# MIAMI BEACH

### Historic Preservation Board

SUBJECT: HPB17-0136, **1244 Ocean Drive.**

The applicant, Ocean Hotel Investment Corp, is requesting an after-the-fact Certificate of Appropriateness for the installation of two retractable awning structures attached to the east façade of the building.

*Photo 1: Unpermitted retractable awning structures sagging, August 4, 2017*

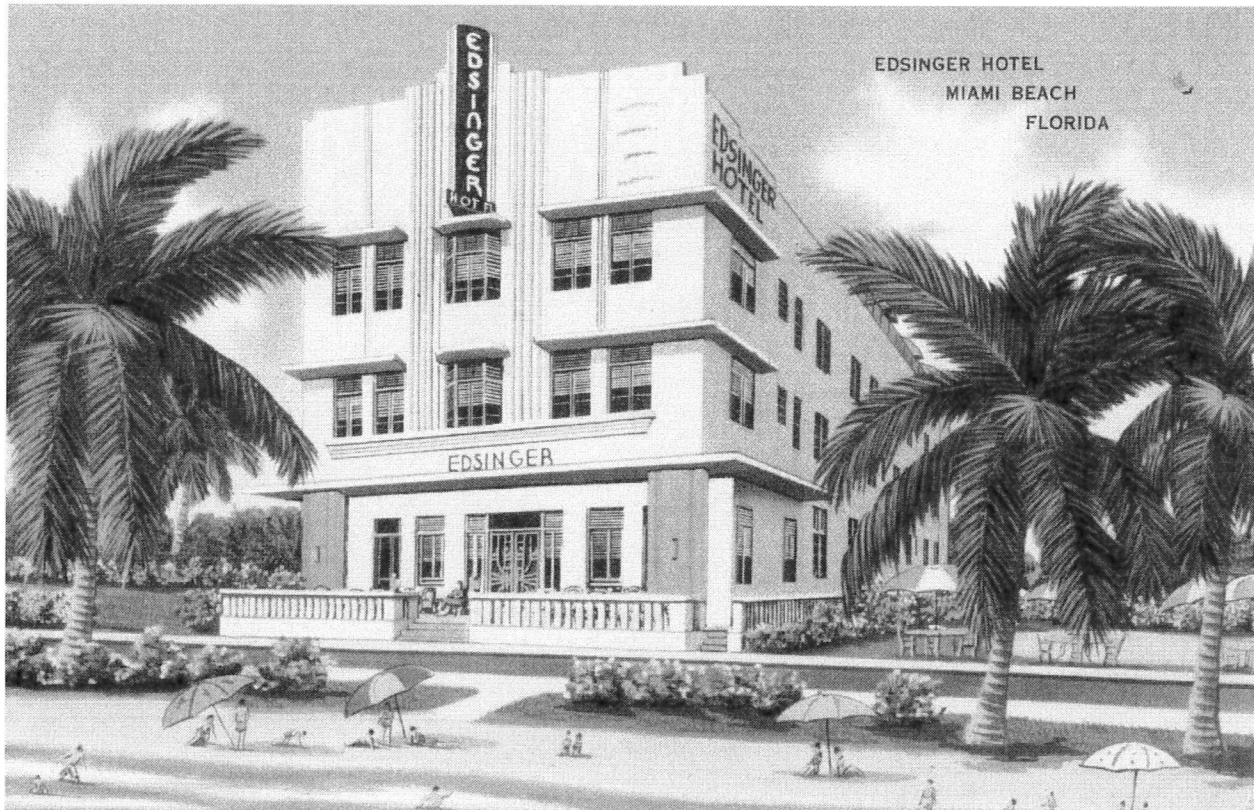
- a. Exterior architectural features.  
**Not Satisfied**  
**The existing unpermitted awning structures are sagging and appear to be failing.**
  - b. General design, scale, massing and arrangement.

While not opposed to the introduction of appropriately designed awnings for this particular building, staff is concerned with the overall size and projection of the 10'-9" x 21'-4" existing awnings. As shown in the photo 1 on the preceding page, the awning structures are sagging and appear to be structurally inadequate. Further, as shown in photo 2, it now appears that the awnings are resting on top of umbrellas. The adopted Ocean Drive Sidewalk Café Design Guidelines expressly prohibit the overlapping of awnings and umbrellas. Staff believes the unpermitted awnings are currently failing, and total failure of the awnings could have serious impacts on the structural integrity of the Contributing Leslie Hotel.

Consequently, staff recommends that the unpermitted awnings be removed immediately and two new retractable awnings be permitted located between the porch columns, each with a maximum projection of 8'-6" into the right-of-way and a minimum separation of 6'-0" between awnings. Further, in order to maintain openness, staff would recommend that there be a minimum clearance height of 8'-6" from the sidewalk to the lowest point of the awning (excluding the fabric valance) and no fixtures, including but not limited to lighting, speakers, fans, heaters, misters and roll-down or other similar side panels permitted to be attached to the awnings.

- a. The existing unpermitted retractable awnings shall be removed. Two new retractable awnings may be introduced on the east façade of the building between the existing columns with a minimum separation of 6'-0" between awnings.

- b. The separate awning structures shall project a maximum of 8'-6" into the right-of-way when fully extended, in a manner to be reviewed and approved by staff consistent with the Certificate of Appropriateness Criteria and/or the directions from the Board.
